1 Products affected

2 Type of change

The inscription at the socket of the fuseholder changes. The voltage rating acc. to UL/CSA is new 600V.

3 Detailed description of change

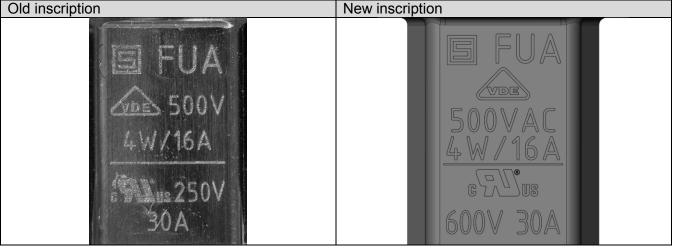
The inscription changes as follows.

The fuseholder FUA has a voltage rating acc. to UL 4248-1 / CSA C22.2 no 4248.1 of 600V (AC/DC). This rating is corrected on the inscription of the socket. Because of this, the layout of the inscription changes.
